Access Compliance Report

Public Rights-of-Way

Intersection ID: 46805	Main Street: ARBOR_CREST_CT	Cross Street: RED_BIRCH_DR	Location: S
ADA ID: 9E23208A963E	Ramp Type: PerpDiag	Initial Pass/Fail: Fail	Overall Compliance: No
			Severity Score: 21.25

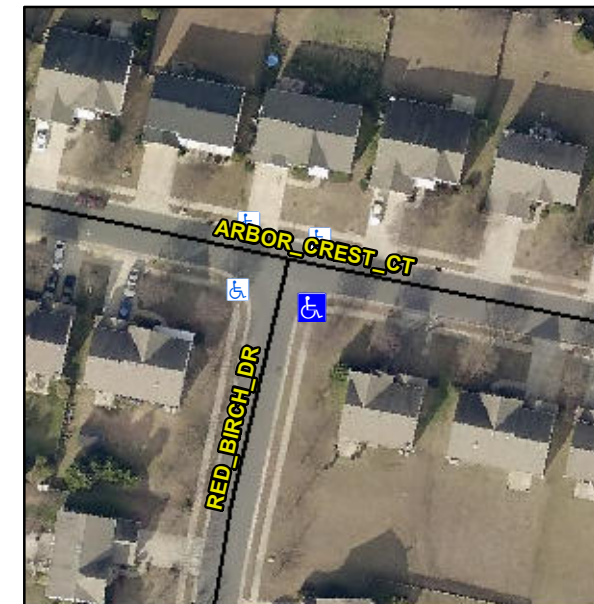
Not Found, R304.5.1, R304.2.2

Compliance	Description	Data	Compliance	Description	Data
N/A	Ramp Length (in)	48.5	No	Ramp Slope (%)	9.6
No	Ramp Width (in)	47.0	Yes	Ramp XSlope (%)	0.2
N/A	Flare Type LT	N/A	N/A	Flare Type RT	N/A
N/A	Flare Slope LT (%)	N/A	N/A	Flare Slope RT (%)	N/A
N/A	Flare Traversable LT?	N/A	N/A	Flare Traversable RT?	N/A
N/A	Landing Length (in)	N/A	N/A	DWS Provided?	N/A
N/A	Landing Width (in)	N/A	N/A	DWS Contrast?	N/A
N/A	Landing Slope (%)	N/A	N/A	DWS Length (in)	N/A
N/A	Landing X Slope (%)	N/A	N/A	DWS Full Width?	N/A
N/A	Landing Curb? (Y/N)	N/A	N/A	DWS Offset (in)	N/A
N/A	Shared Landing?	N/A			
N/A	Gutter Ponding?	N/A	N/A	Gutter Slope (%)	N/A
N/A	Gutter Lip Ht (in)	N/A	N/A	Gutter X Slope (%)	N/A
N/A	Painted X Walk1?	No	N/A	Painted X Walk2?	No
	X Walk 1 Direction	To NE		X Walk 2 Direction	To NW
N/A	X Walk 1 Width (in)	N/A	N/A	X Walk 2 Width (in)	N/A
	X Walk 1 Slope (%)	1.3		X Walk 2 Slope (%)	3.3
	X Walk 1 X Slope (%)	3.2		X Walk 2 X Slope (%)	2.8

Remove & Replace Curb Ramp With Two New Directional Ramps or Equivalent.
